**Development Permit Panel
Electronic Meeting**

1. DEVELOPMENT PERMIT 21-933765
(REDMS No. 6862789)

APPLICANT: Interface Architecture Inc.

PROPERTY LOCATION: 9300 and 9320 Cambie Road

Initially approved plan

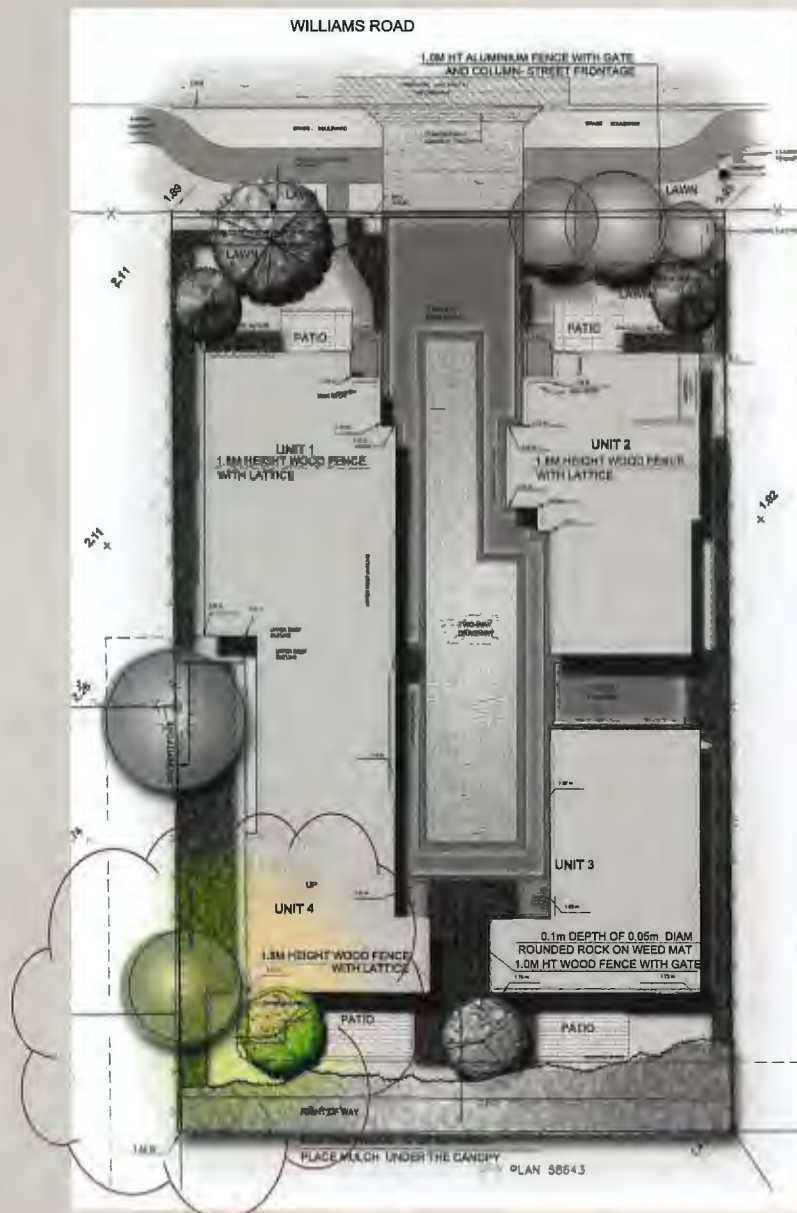
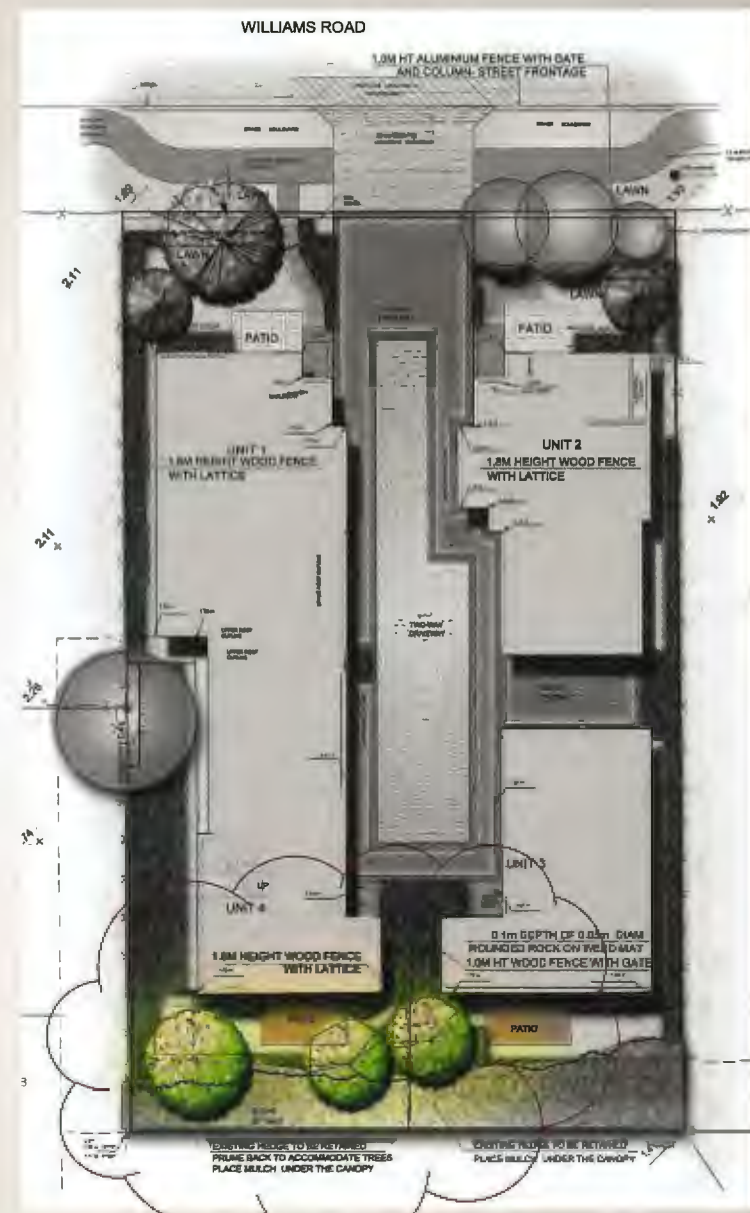
- the original Tree Management Plan associated with the previously approved DP 20-890821 indicated that three trees located at the southwest corner and along the south side of Lot A were to be removed;
- during demolition of the detached garage, a plum tree (tag #593) located in the west side yard of Lot A and identified for retention in the original Tree Management Plan was accidentally damaged and subsequently removed;
- the applicant is proposing that the removed plum tree be replaced with a Quercus Robur Crimson Spire tree and planted slightly farther away from the building; and
- the applicant is proposing that the replacement tree be slightly moved in order to provide more space for the growth of the replacement tree at maturity.

In addition, Denitsa Dimitrova, PMG Landscape Architects, noted that (i) a 10 cm caliper Quercos Robur Crimson Spire tree is proposed to be planted in lieu of the removed plum tree, (ii) the size of the other replacement trees for the entire site as provided in the original landscape plan will be increased from 6 cm to 8 cm caliper, and (iii) the replacement trees will be planted two to three meters from the property line.

That the attached plans involving changes to the proposed Tree Management Plan and Landscape Plan be considered to be in General Compliance with the approved Development Permit (DP 20-890821).

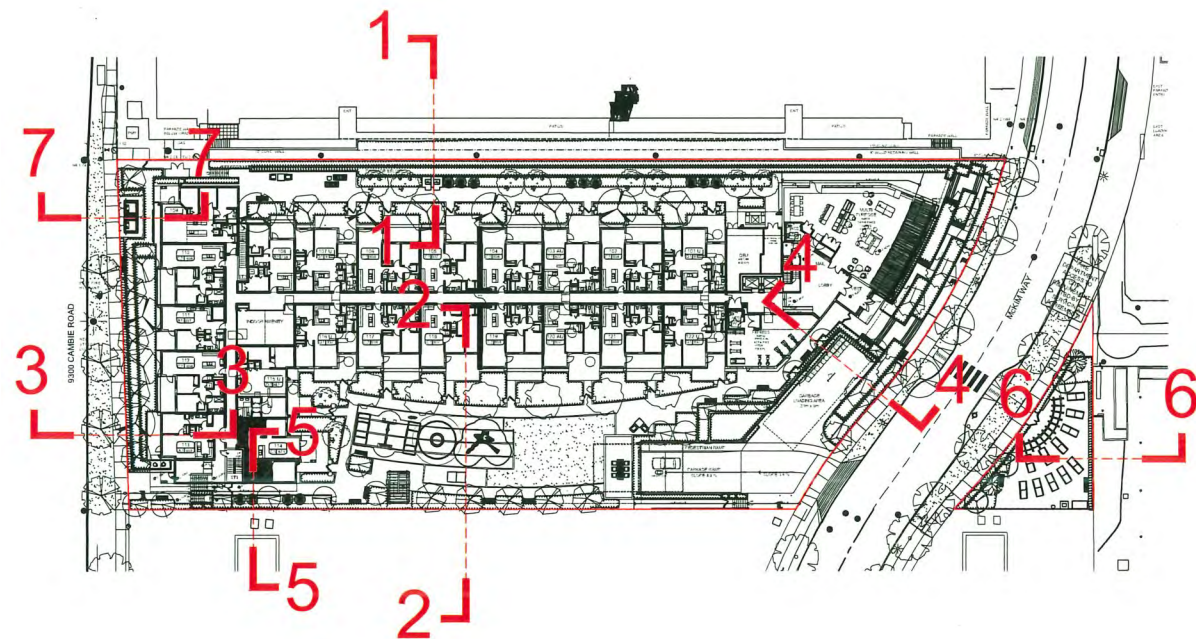
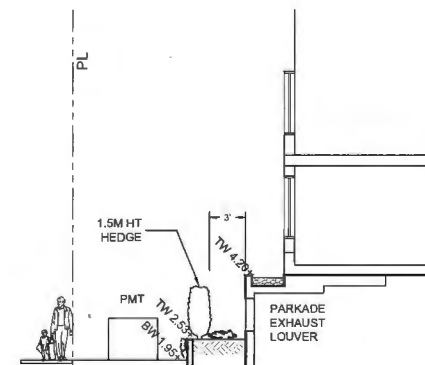
- support the Panel comment that some or all of those planting boxes should be completely accessible to people in wheelchairs;

Planting boxes are at 2 heights (12" & 24", see sheet L8).
